RESPONSE TO
NRC HUMAN FACTORS ENGINEERING
PRELIMINARY DESIGN ASSESSMENT AUDIT
REPORT OF AUGUST 26, 1983

WASHINGTON PUBLIC POWER SUPPLY SYSTEM
NUCLEAR PROJECT NO. 2 (WNP-2)

October 7, 1983

FIGURE 1

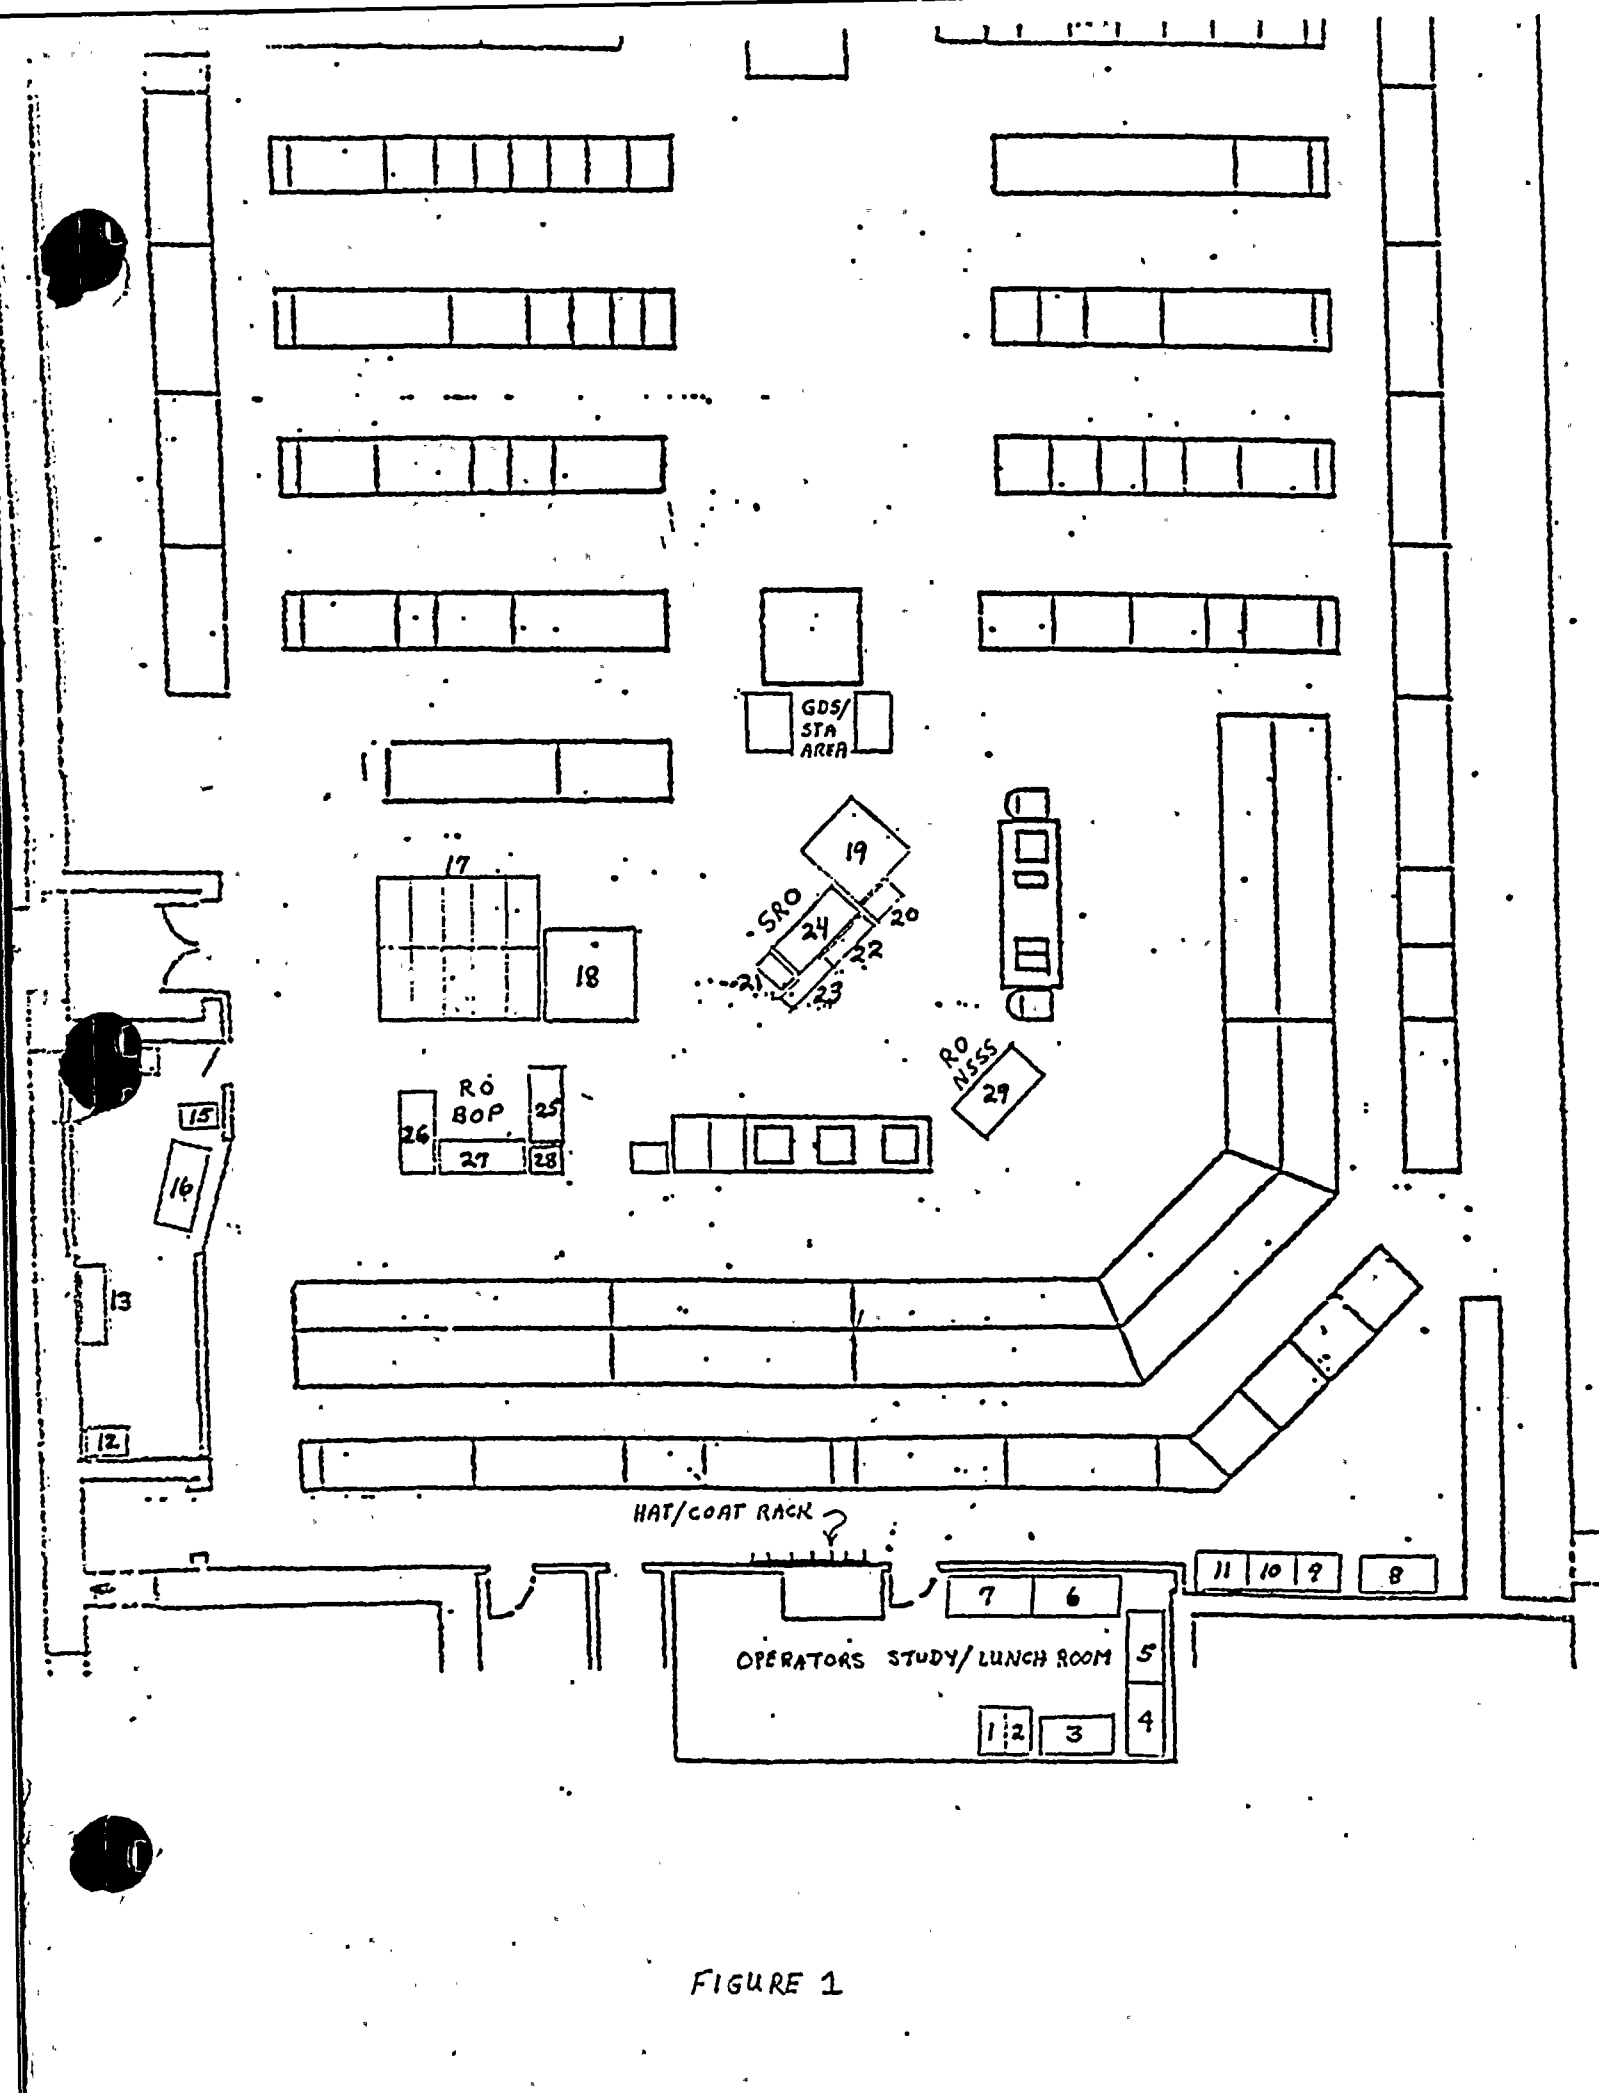
Control room furnishings and equipment were not completely installed. Adequacy of furnishings, obstacles to operator movement, and presence of unnecessary furnishings and equipment could not be evaluated.

RESPONSE: The control room primary operating area has been essentially arranged in its final configuration (see Figure 1). Two concerns were noted:

1. Access to print table (item 18) was poor for the senior RO and NSSS operator. The print files (item 17) and the print table were reversed in sequence. This provides improved access and also improved visibility for the BOP operator from his desk to Panel P851 (Board S).
2. The two black and white CRTs located between the senior RO and Panel P601 are at such a height that the senior RO's view is partially obstructed. See NRC Finding D-7.3 for response on this item.

With the above changes, furnishings appear adequate; operator movement is unobstructed within their areas of responsibility; communications is adequate at all work stations; procedures are readily accessible from a central location; operator visibility from their respective work stations to the panels is unobstructed, including from the shift manager's office; and access to emergency equipment and spare parts is adequate. In general, the arrangement provides a functional control room for both normal and abnormal operation.

The arrangement of the shift manager's office and the operator's lunch/study room has not been completed as yet. These areas will be in the proposed arrangement by fuel load. A functional review will be completed of these areas when the arrangement has been completed.
